**ADDENDUM
NO. 2**

Richland Bean Blossom Schools Roofing & Mechanical Renovations
Various Schools Locations
Ellettsville, IN 47429

PROJECT: Richland Bean Blossom – Roofing & HVAC
Junior High School

DATE OF ADDENDUM: February 10, 2026

1 JUNIOR HIGH SCHOOL ROOF DEMO PLAN
SCALE: 1" = 20'-0"

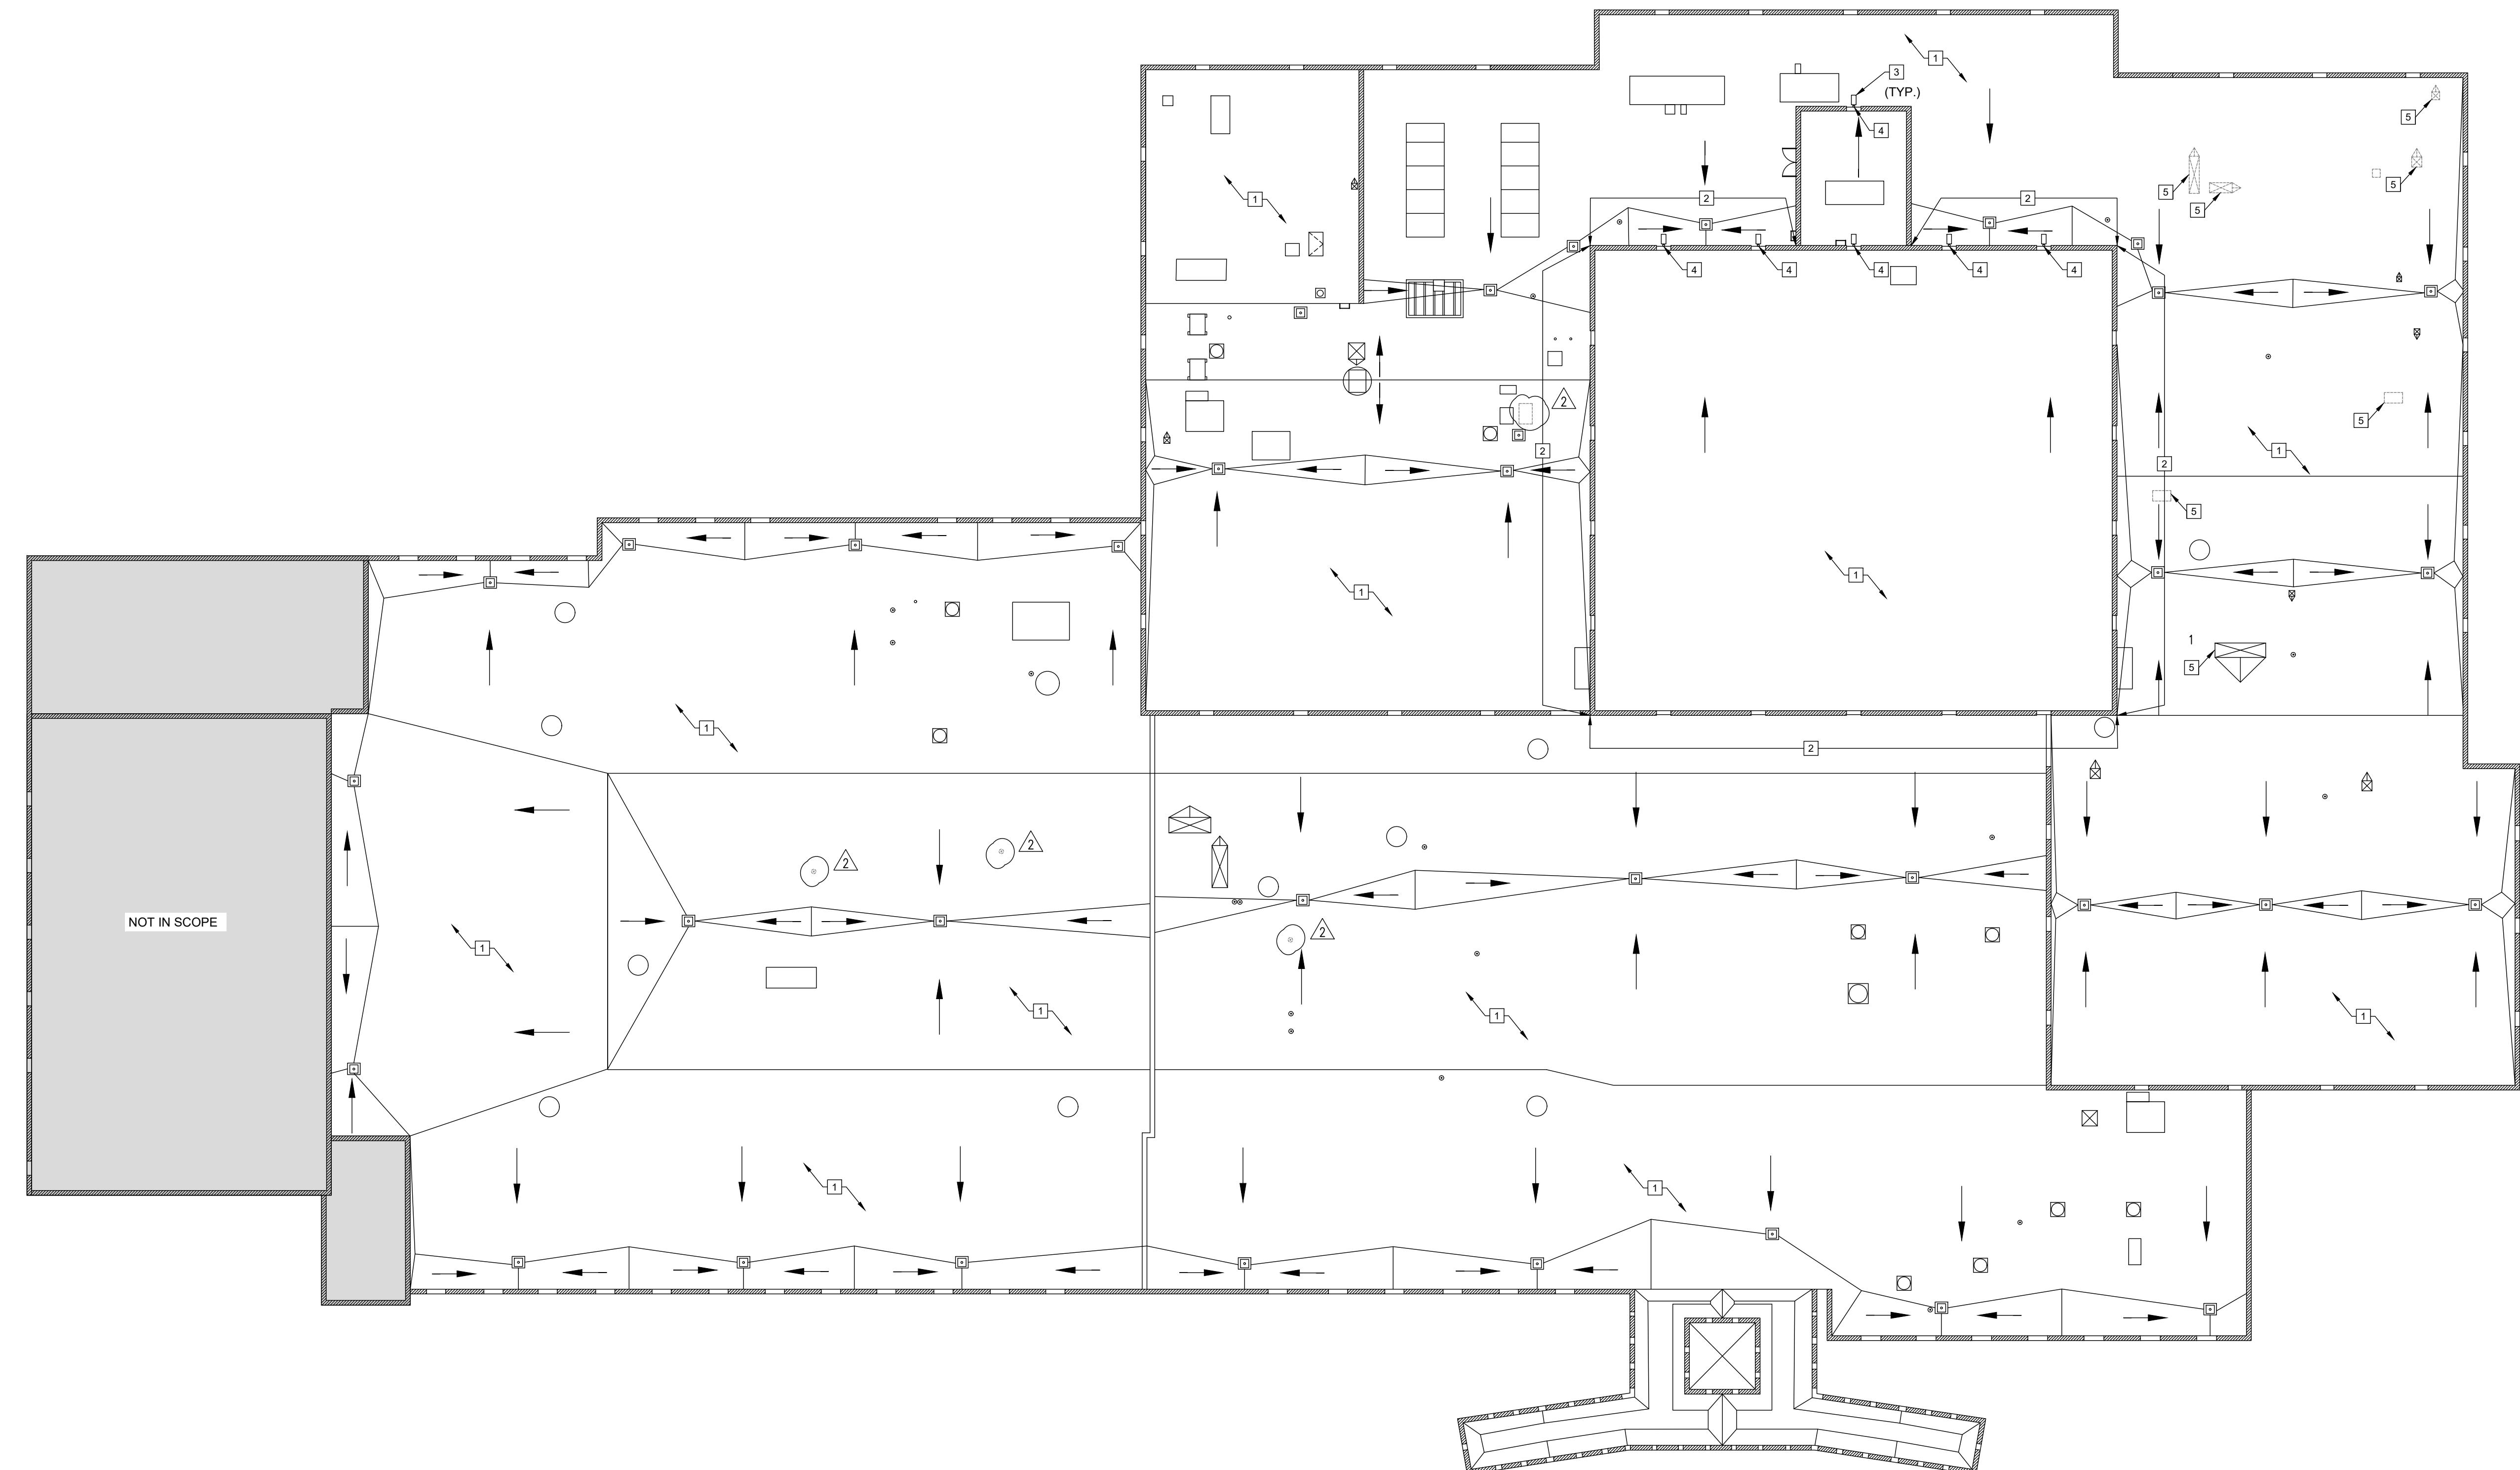
Change: added four curbs to be demo.

1 JUNIOR HIGH SCHOOL ROOF PLAN
SCALE: 1" = 20'-0"

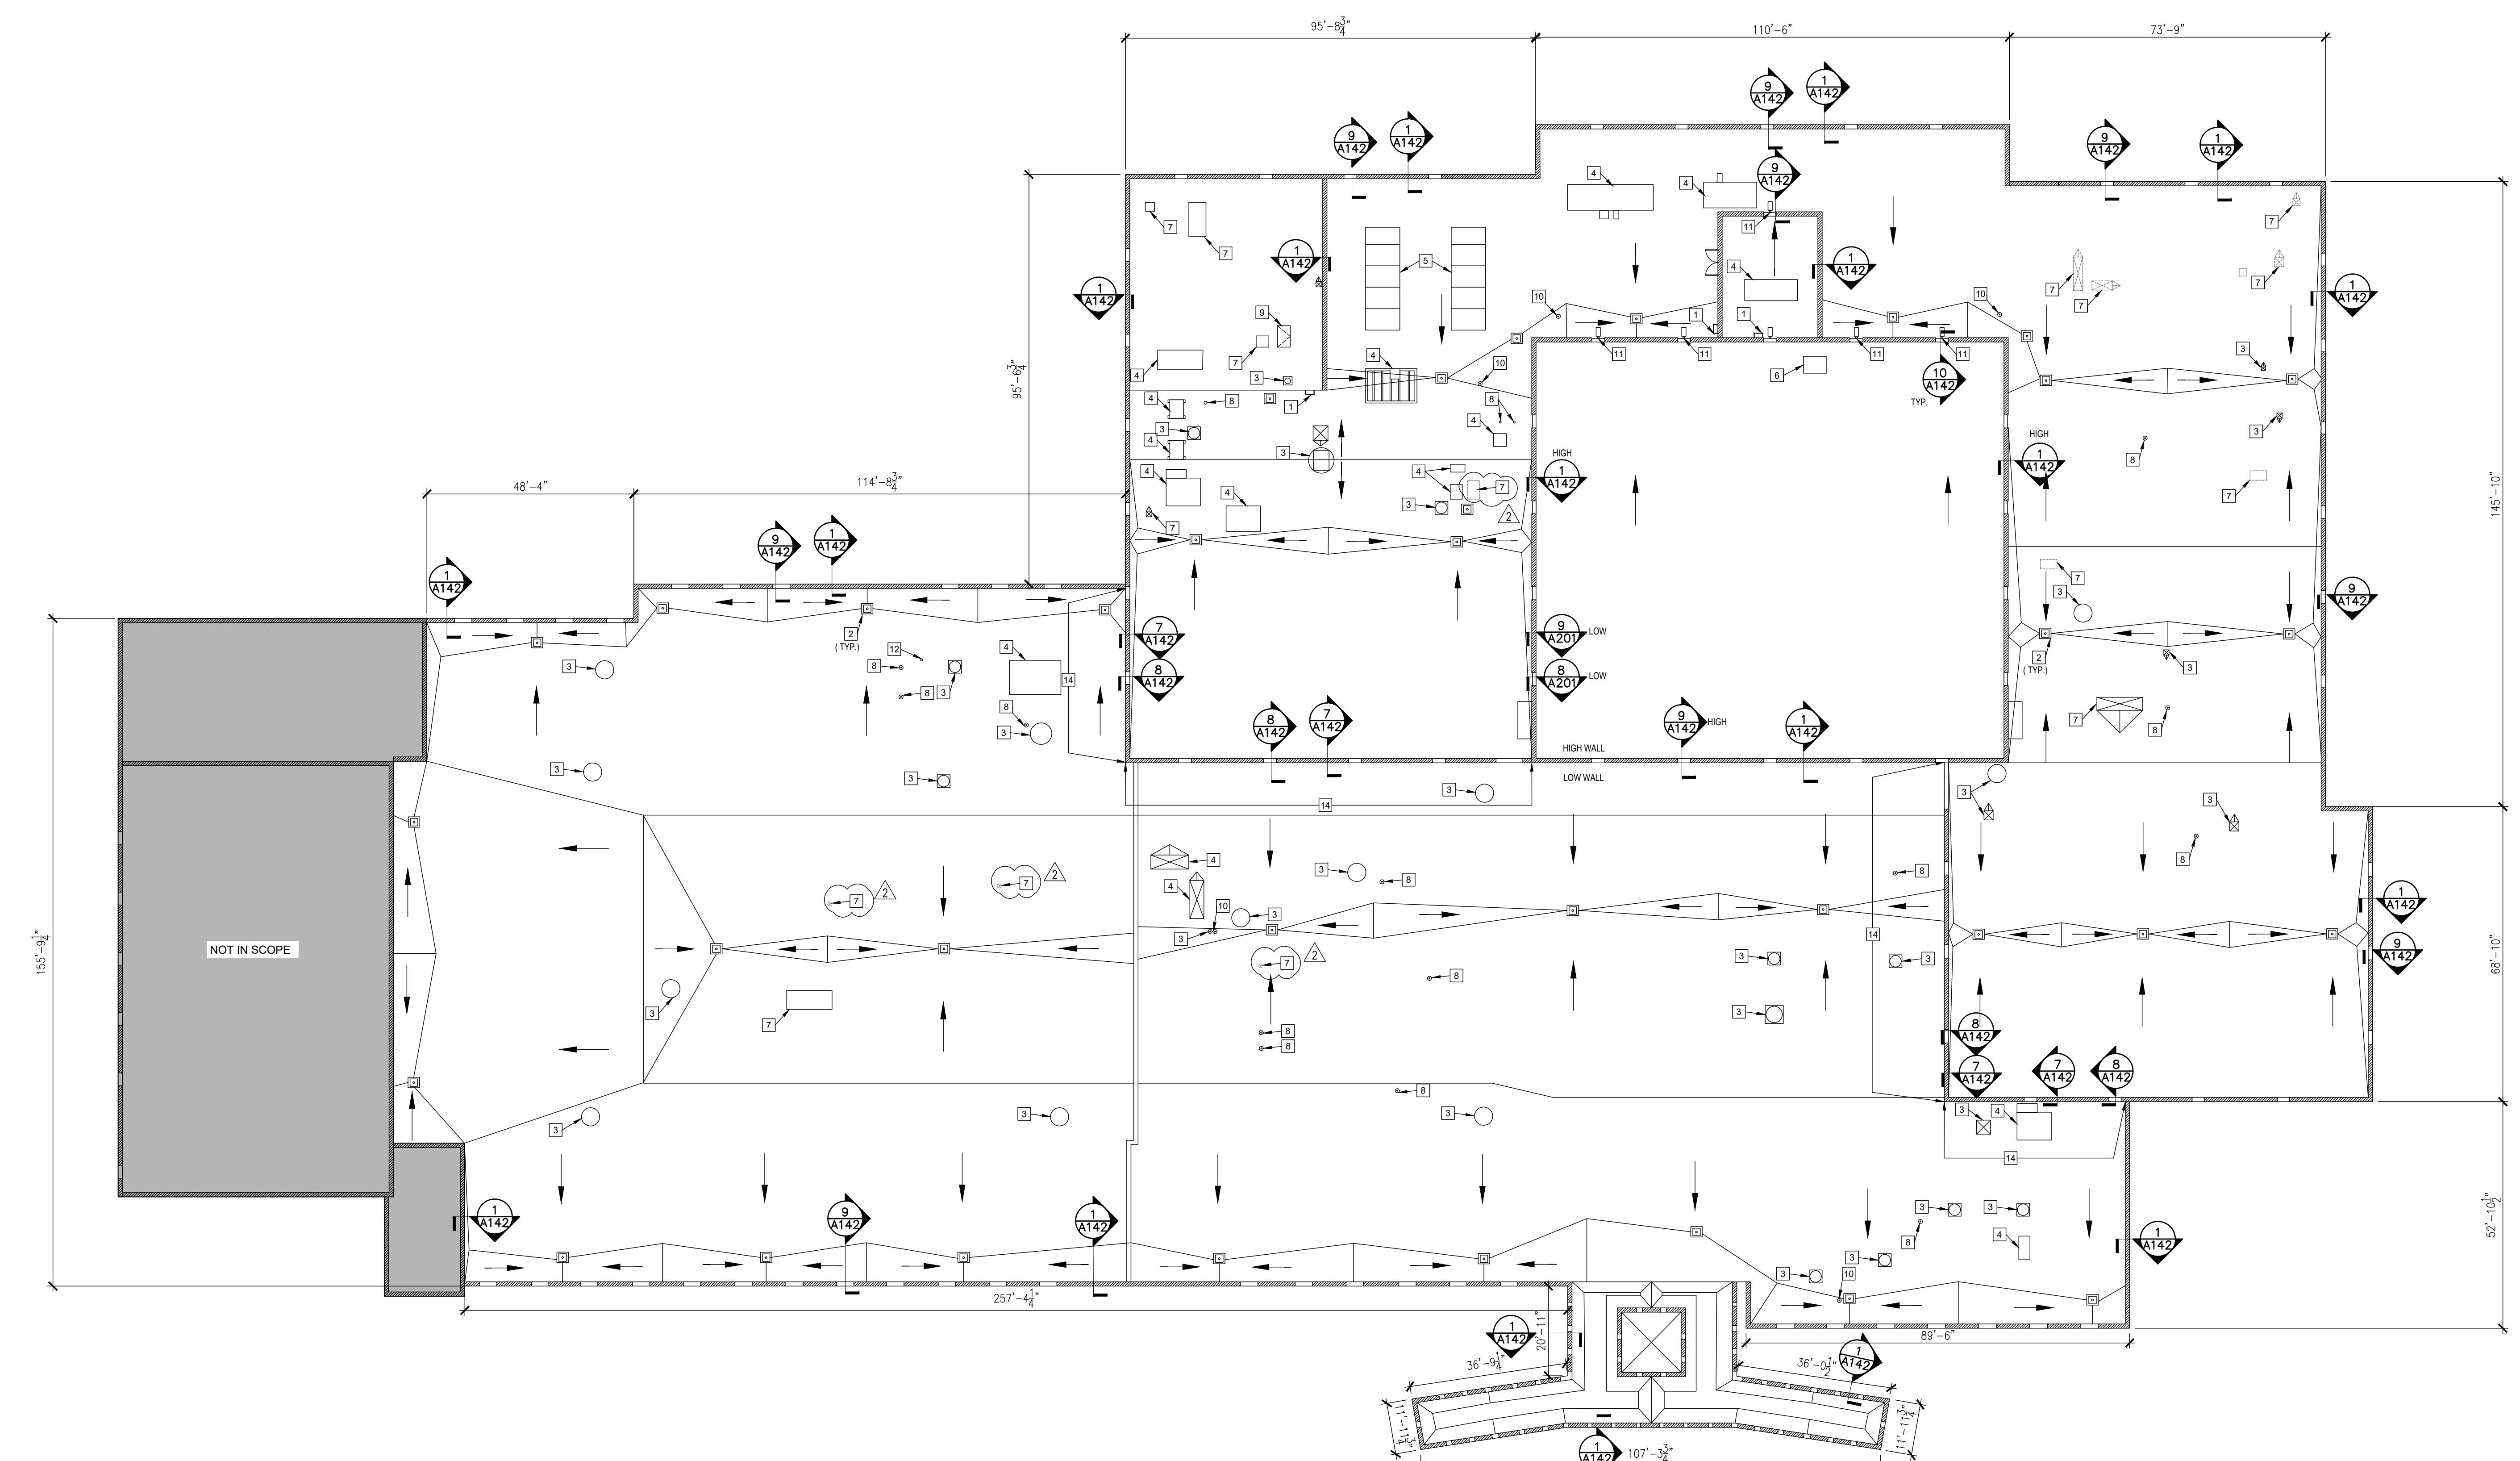
Change: Changed some #3 to #7. These will have to be field verified.
